SPI-2 Issues

Capacitance Balance
Single Ended Termination Current

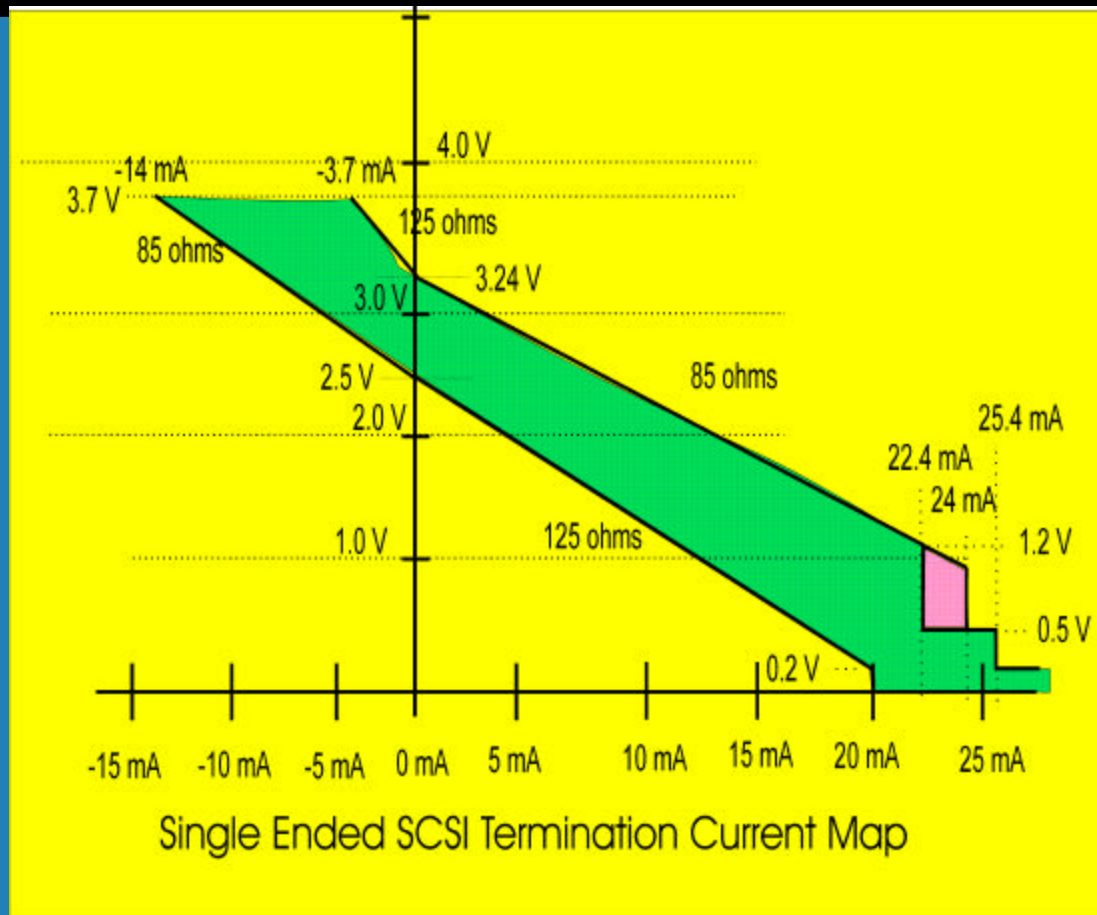
- The 0.5 pF balance capacitance for LVD SCSI (Table 29 SPI-2R13) and HVD SCSI (Table 36 SPI-2R13) are extremely hard meet for a proto type and impossible to meet in production. Measuring the parts 2-3 Controller, Terminator (Maybe) and connector with the etch board to 0.5 pF is an impossible task. The components have different capacitance reading which are effected by the ground plane and the proximity to cables or metal objects to the module will change the capacitance, as much as several pFs and the difference between lines can be much greater than 0.5 pF.

- Terminator parts vary 0.5 pF depending on how they are mounted. BGA controllers have reported 0.6 pF differences in pin capacitance. The connector has different capacitance from the difference between the sides of the connectors. capacitance more than the allowed balance. 2 pF would be possible, with all the components considered.

- Table 29 and 36 |C1-C2| (pF) should be increased to 1 pF minimum, 2 pF would be better.
